TRAILS AT ASPEN RIDGE FILING NO. 2

FINAL GRADING & EROSION CONTROL PLANS

NOVEMBER, 2019

LEGEND & ABBREVIATION NOTES

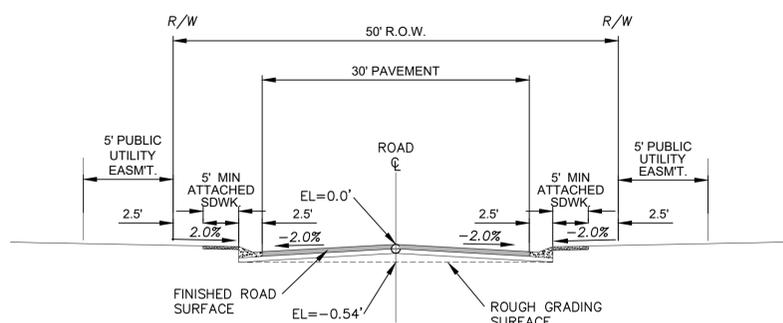
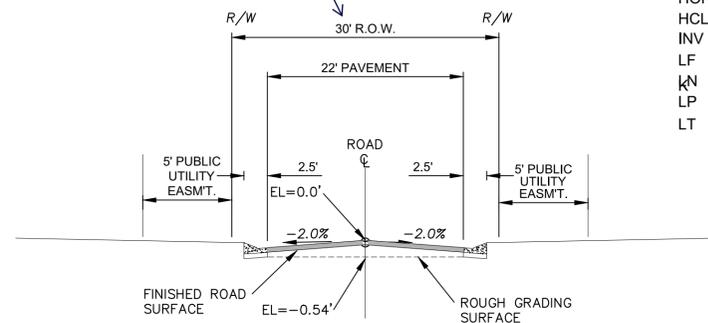
Private road to be located within a tract, not ROW

Private Roadway typical section has been updated accordingly

GRADING & EROSION CONTROL PLAN

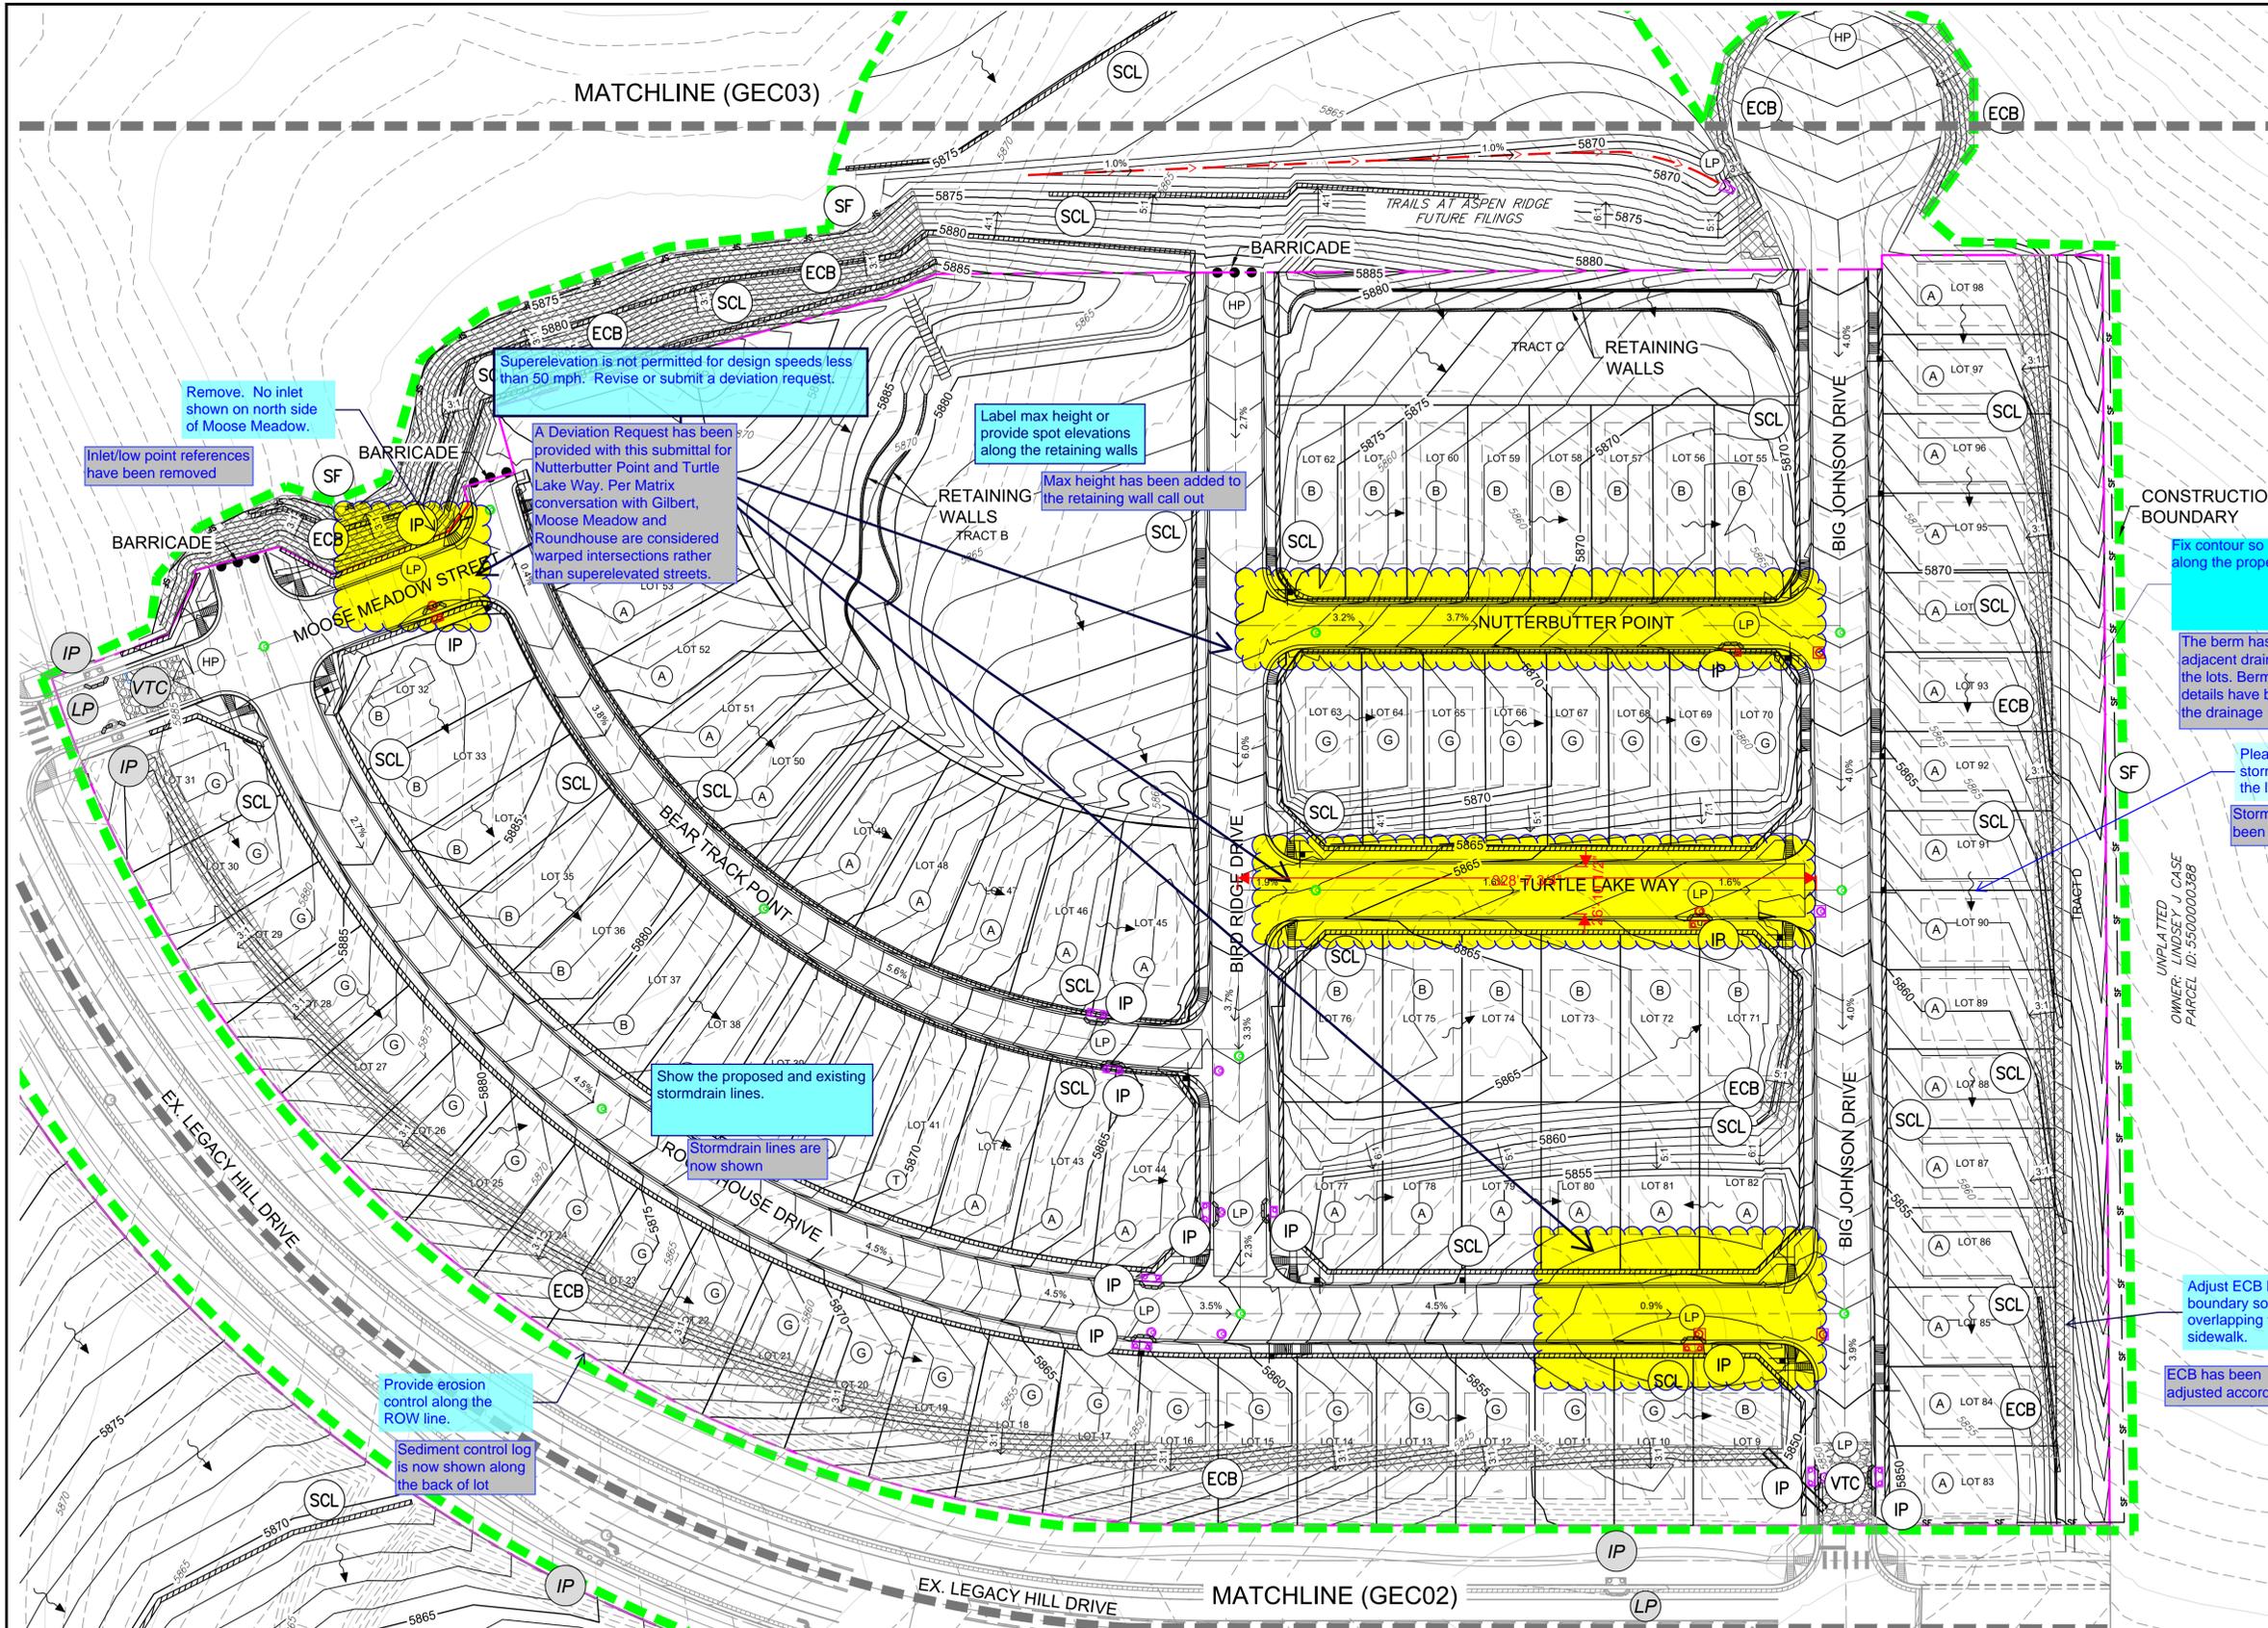
Remove. No inlet shown on north side of Moose Meadow.

Superelevation is not permitted for design speeds less than 50 mph. Revise or submit a deviation request.

Label max height or provide spot elevations along the retaining walls

Fix contour so it doesn't show berm along the property line.

Please add these stormflow arrows to the legend.

Show the proposed and existing stormdrain lines.

Provide erosion control along the ROW line.

Adjust ECB hatch boundary so it's not overlapping the sidewalk.

Inlet/low point references have been removed

A Deviation Request has been provided with this submittal for Nutterbutter Point and Turtle Lake Way. Per Matrix conversation with Gilbert, Moose Meadow and Roundhouse are considered warped intersections rather than superelevated streets.

Max height has been added to the retaining wall call out

The berm has been proposed to avoid adjacent drainage being conveyed through the lots. Berm/Swale information and details have been added to the plans and the drainage report

Storm flow arrows have been added to the legend

Stormdrain lines are now shown

Sediment control log is now shown along the back of lot

ECB has been adjusted accordingly

GRADING & EROSION CONTROL PLAN

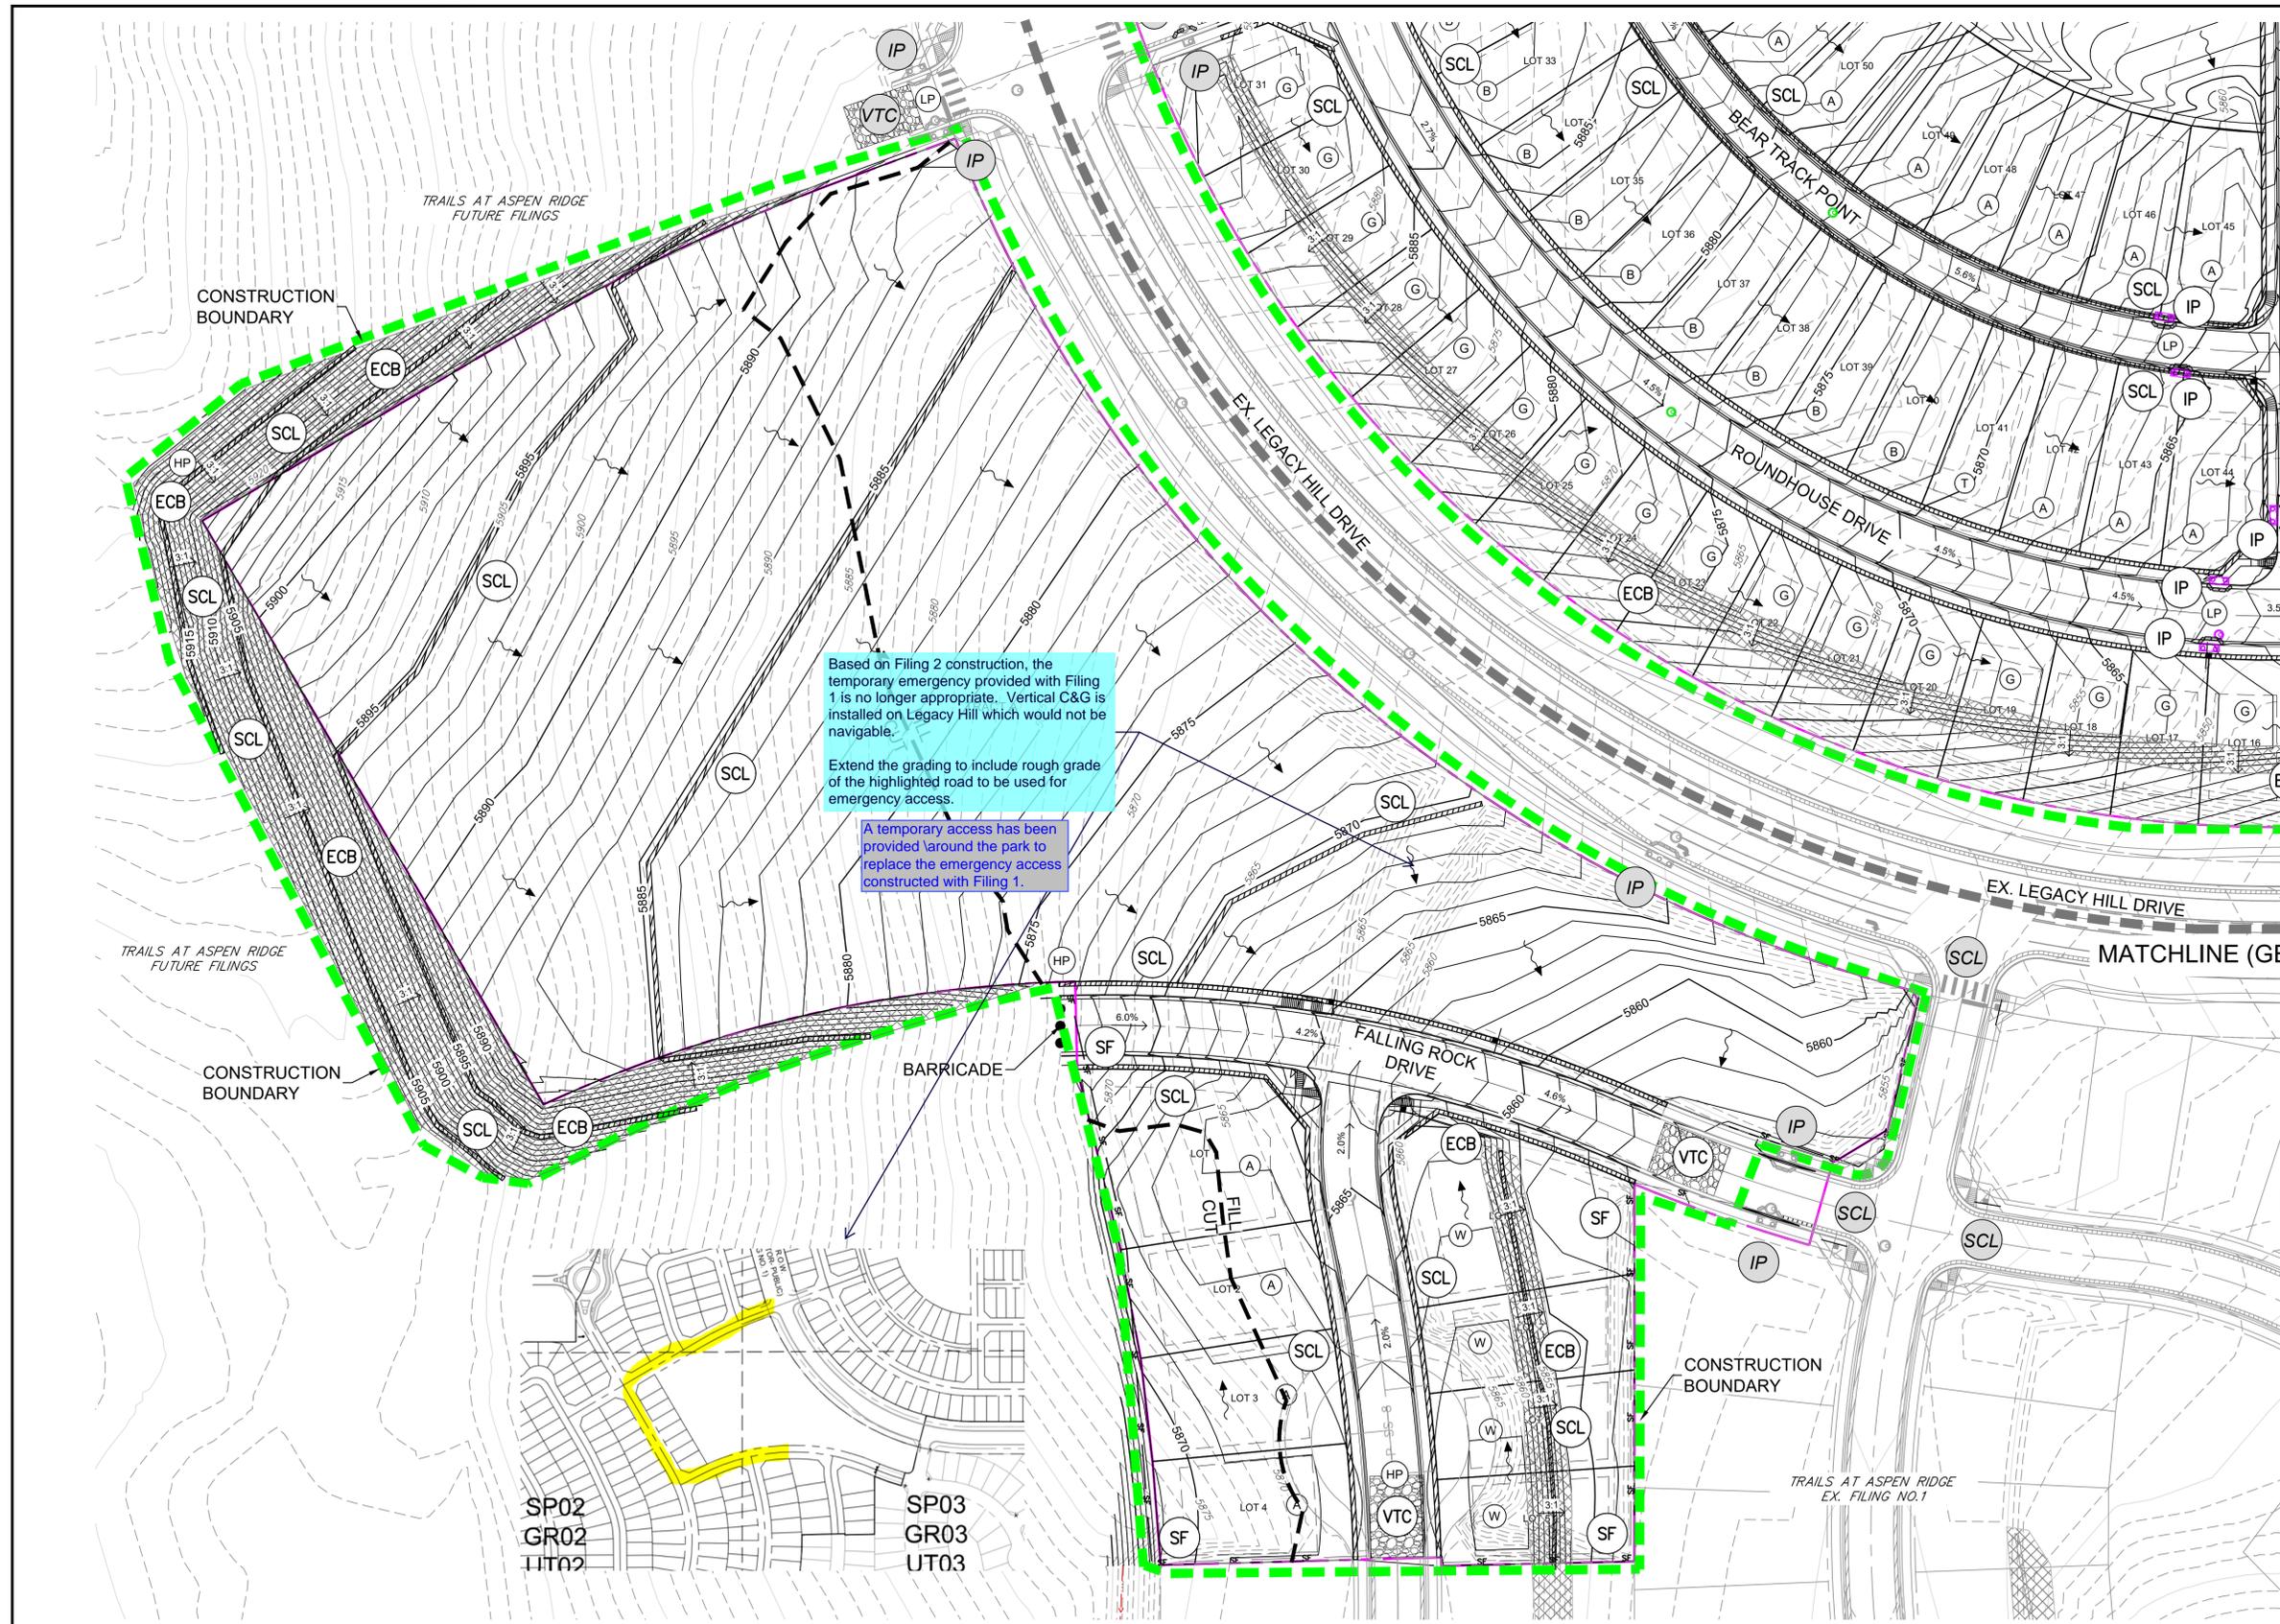
Based on Filing 2 construction, the temporary emergency provided with Filing 1 is no longer appropriate. Vertical C&G is installed on Legacy Hill which would not be navigable.

Extend the grading to include rough grade of the highlighted road to be used for emergency access.

Temporary sediment basins should be provided in your initial sequence.

A temporary access has been provided around the park to replace the emergency access constructed with Filing 1.

Revised accordingly
